Service Bulletin

FLIGHT CONTROLS - FLAP STRUCTURE MODIFICATION

SB 31-27-35
Recommended
Page 1 of 42

LEARJET 31 Service Bulletin

Flap Lower Skin Rivet Location
Figure 4 (Sheet 1 of 4)

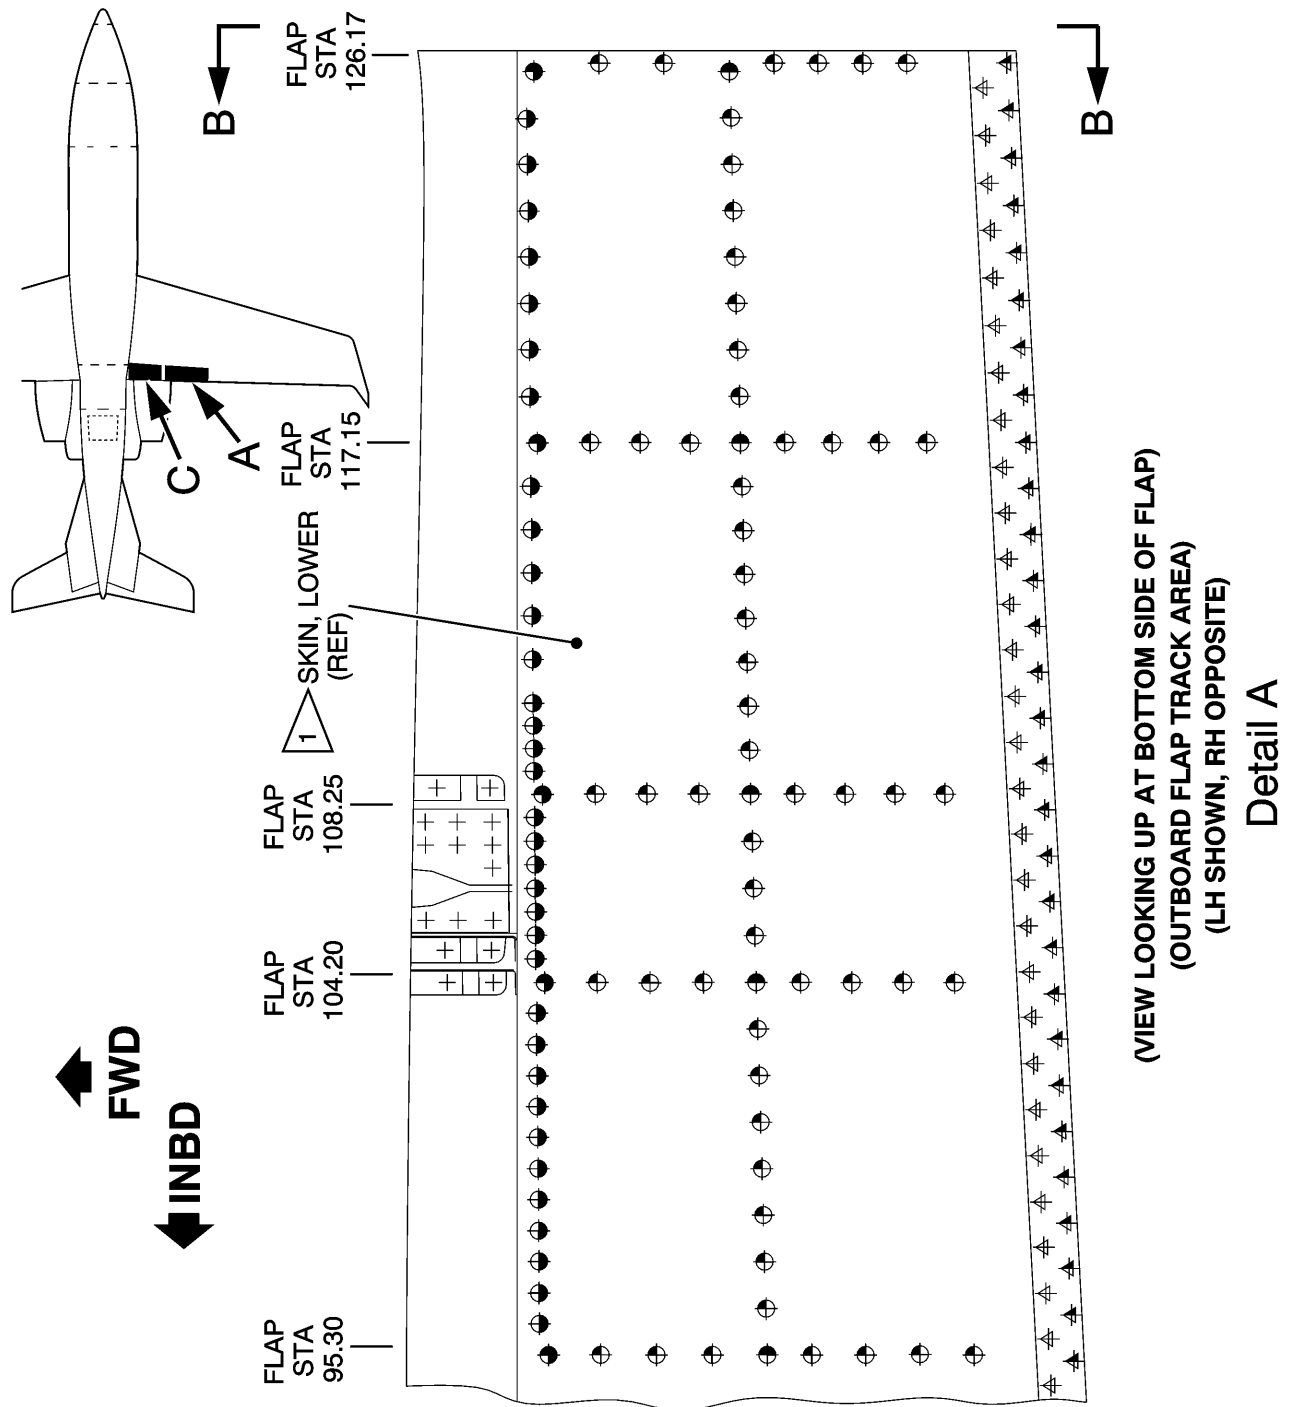
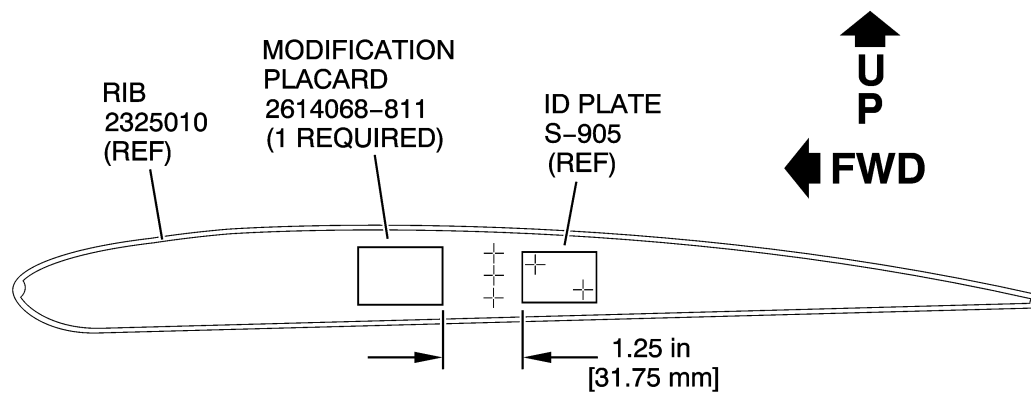
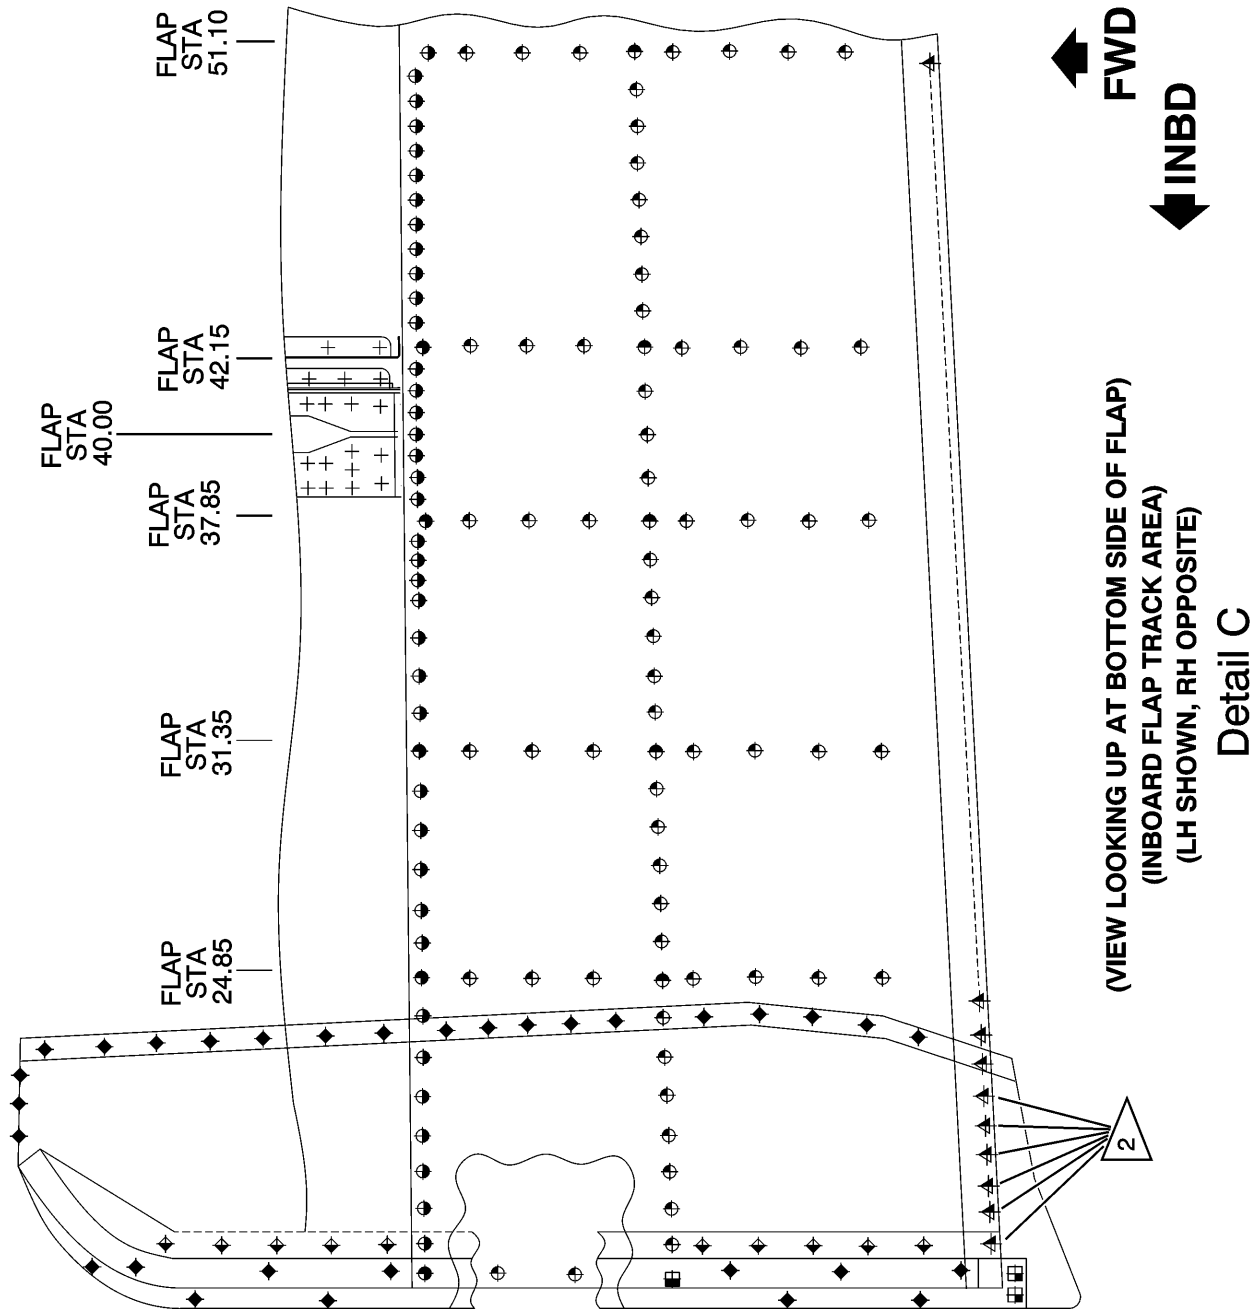
- (a) Drill out rivets, as required, to allow the lower trailing edge skins to be peeled back to gain access to the spars and the rib attaching rivets. (Refer to [Chapter 51 of the Structural Repair Manual](#).) (See [Figure 4](#) for approximate rivet locations.)

- (a) Drill out rivets, as required, to allow the lower trailing edge skin to be peeled back to gain access to the spar and the rib attaching rivets. (Refer to [Chapter 51 of the Structural Repair Manual](#).) (See [Figure 4](#) for approximate rivet locations.)

- (12) Install the skins with the rivets supplied in conjunction with the adhesive bonding method as follows: (See [Figure 4](#).)

- (13) Apply the modification placard to the flap, complete the information, and clear coat the modification placard, supplied in the -817 kit as follows: (See [Figure 4](#), View B-B.)

Flap Track Support Bracket with Allowable Shims
Figure 5 (Sheet 1 of 3)

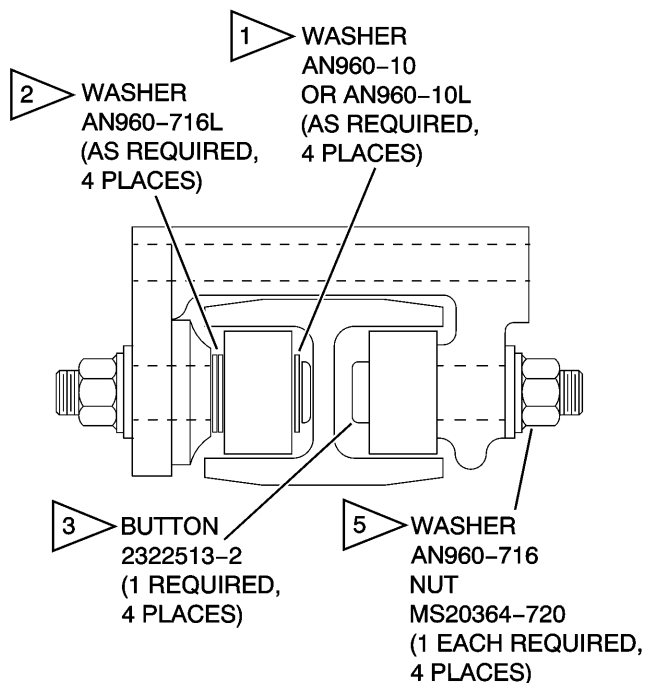
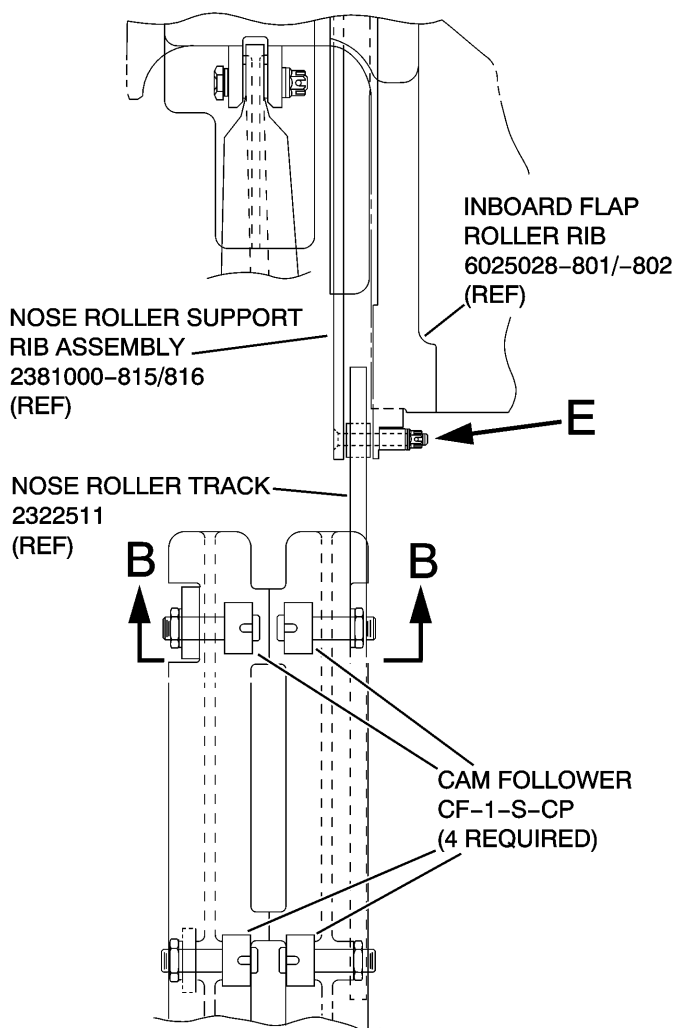
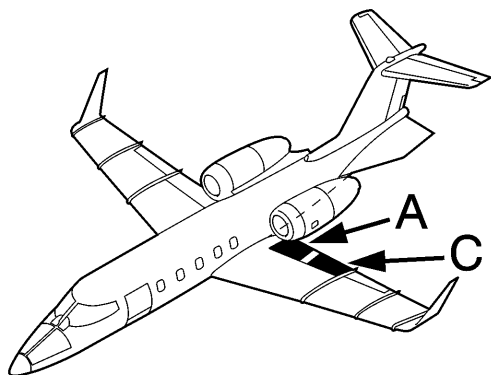
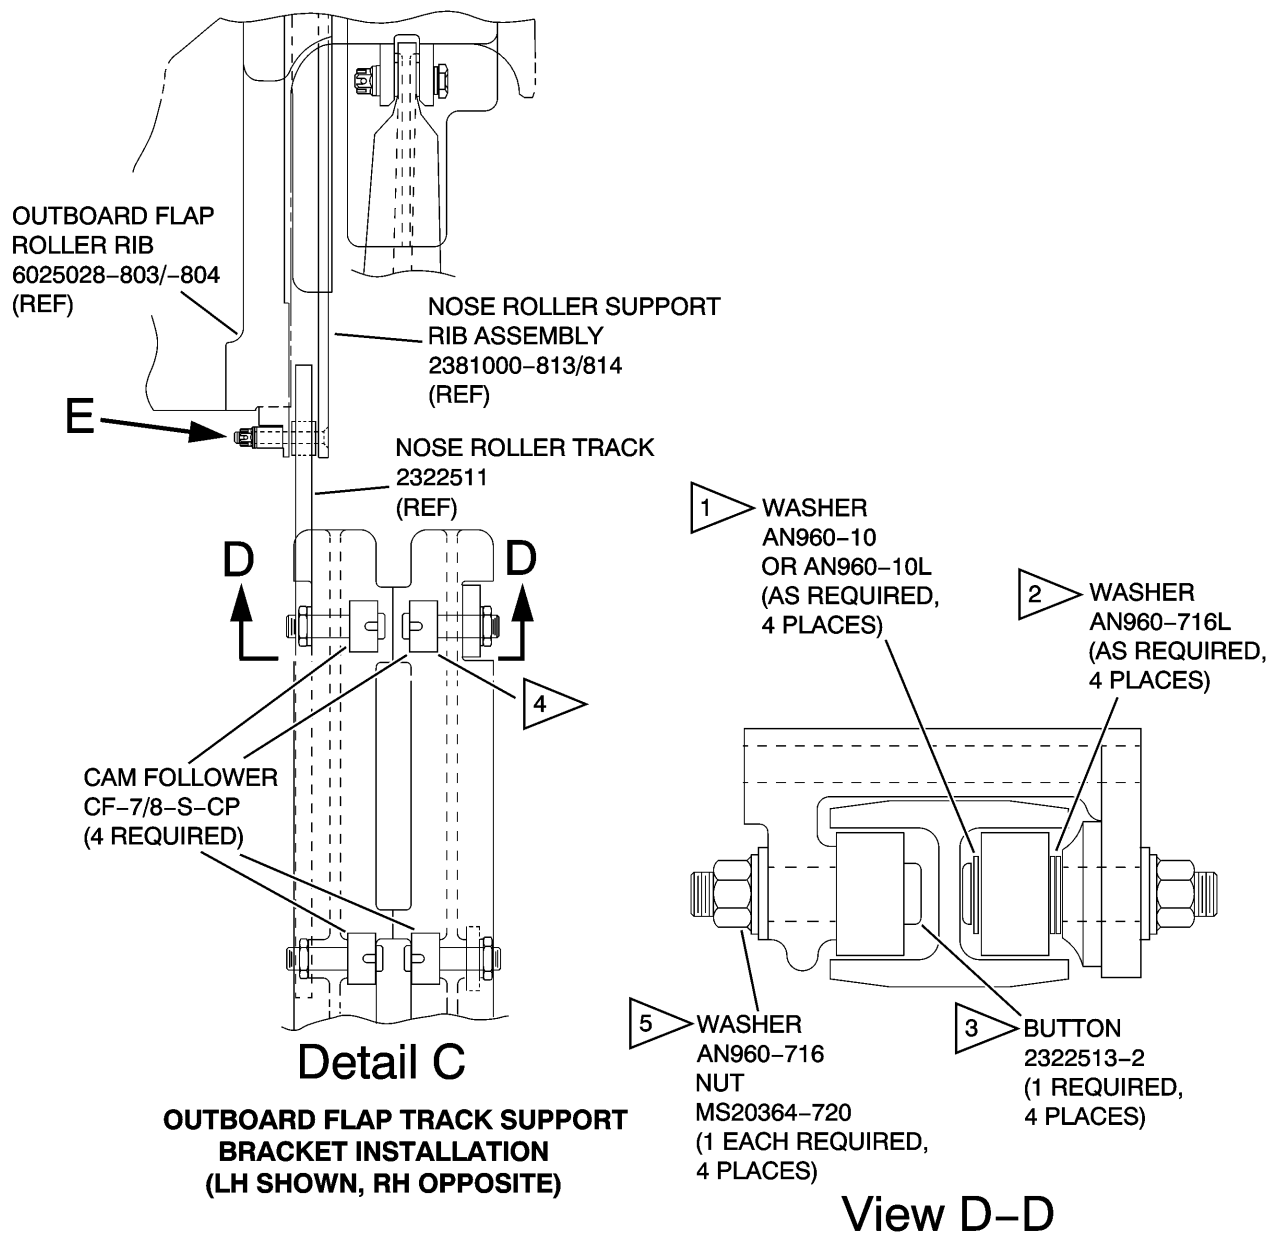
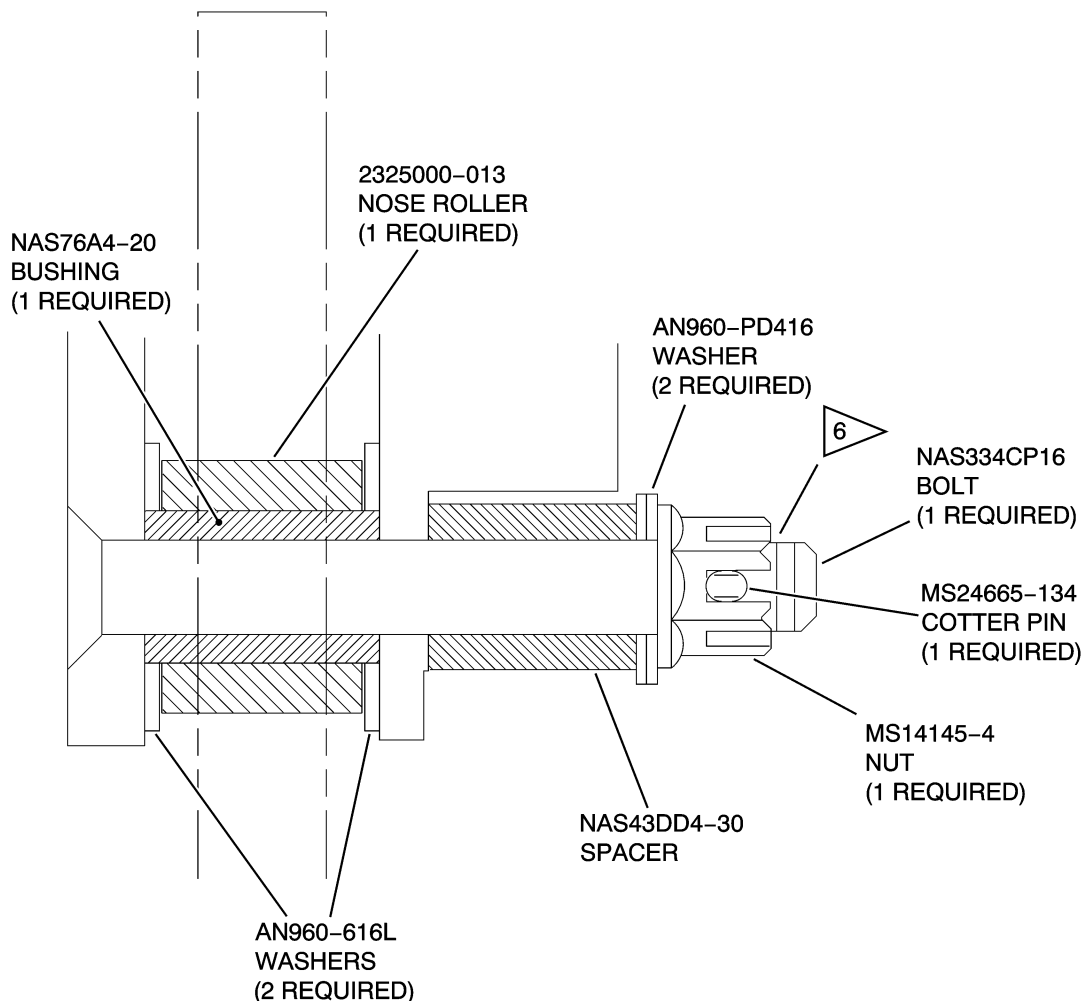
- (a) Install any combination of cam follower buttons to tighten up and control the spanwise movement of the flap. (See [Figure 5](#).)
 - (b) Shim the cam follower buttons using one (1) washer under button as required. (See [Figure 5](#).)

- (c) Shim the cam followers using a maximum of two (2) washers per follower as required. (See [Figure 5](#).)
 - (d) If further adjustment is required, shim the nose roller track away from the flap track support fitting with one (1) washer under each nose roller track bolt. (See [Figure 6](#).)

Flap Track Support with Shimmed Nose Track
Figure 6 (Sheet 1 of 2)

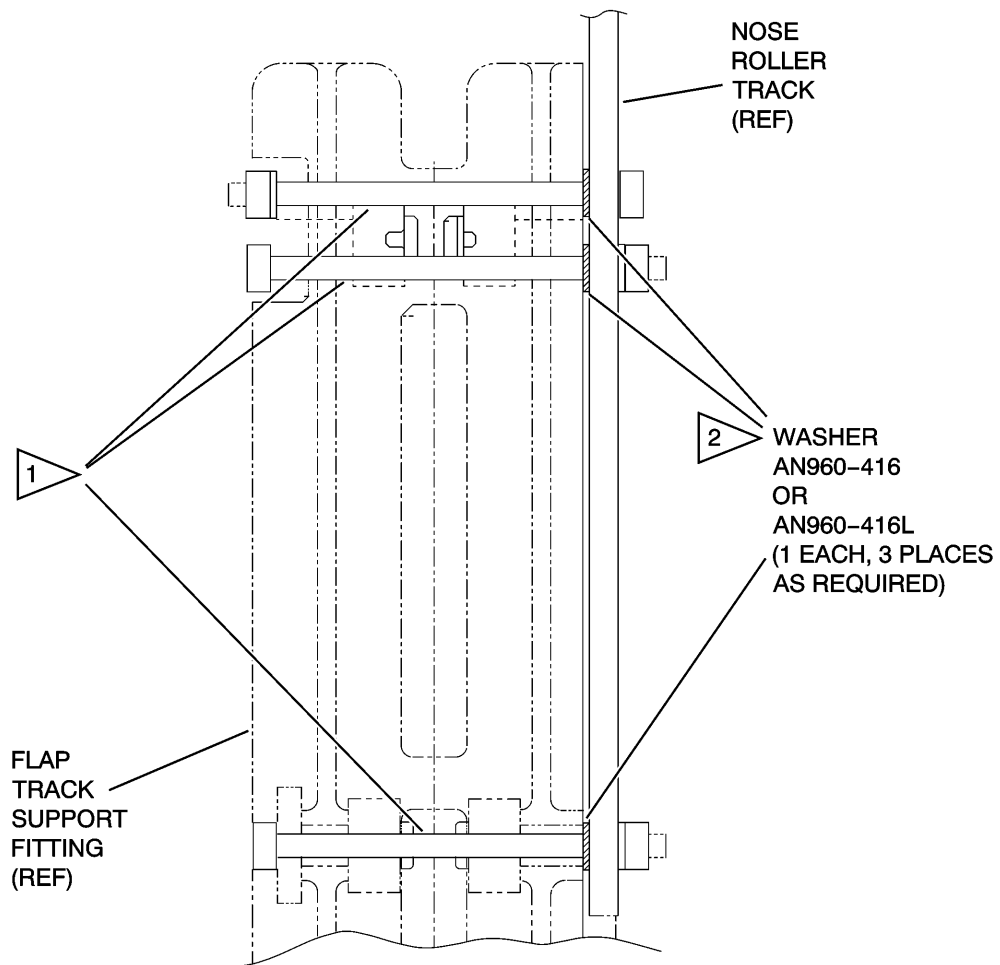
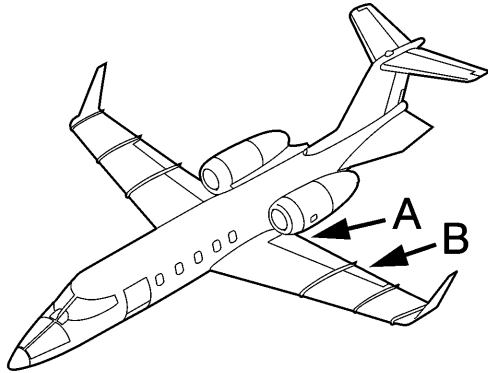
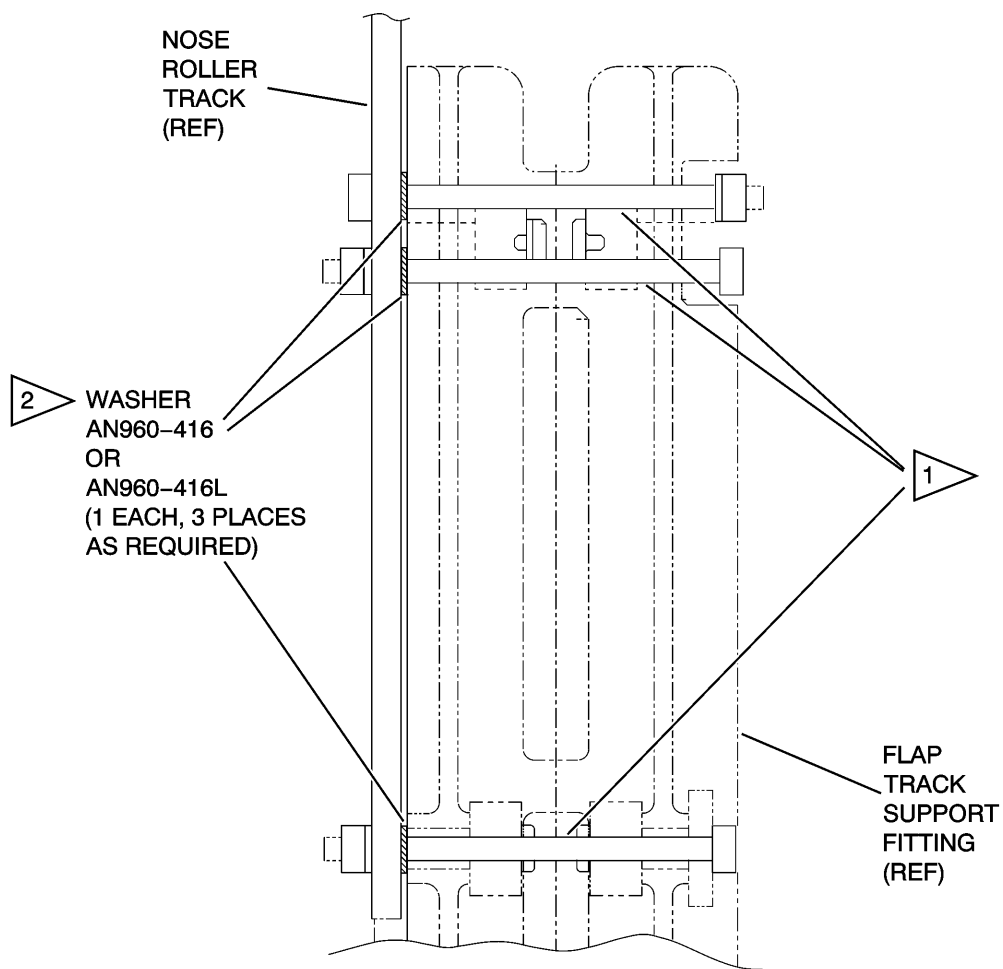
- 1 Permissible to replace bolts with one size longer when necessary for proper nut engagement.
- 2 One washer may be used under each nose roller track bolt for flap rigging.
